Queenstown Airspace Classification Review – Summary of Submissions

A formal review of the classification of the airspace at Queenstown aerodrome and the environs has been initiated by CAA and consultation with airspace users commenced in February 2014.

Summary of submissions

Reported resolution advisories for the period 1 April 2011 until 31 March 2014

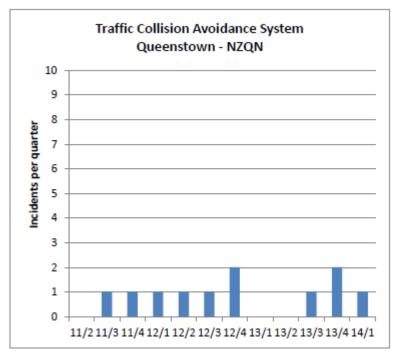
There are still on-going ACAS resolution advisories being reported at an average of one every quarter. The total of 11 in the chart below is the second highest within New Zealand over the period. The five highest ranking aerodromes had a similar average each quarter, but the other four aerodromes have 2-3 times the number of annual movements.
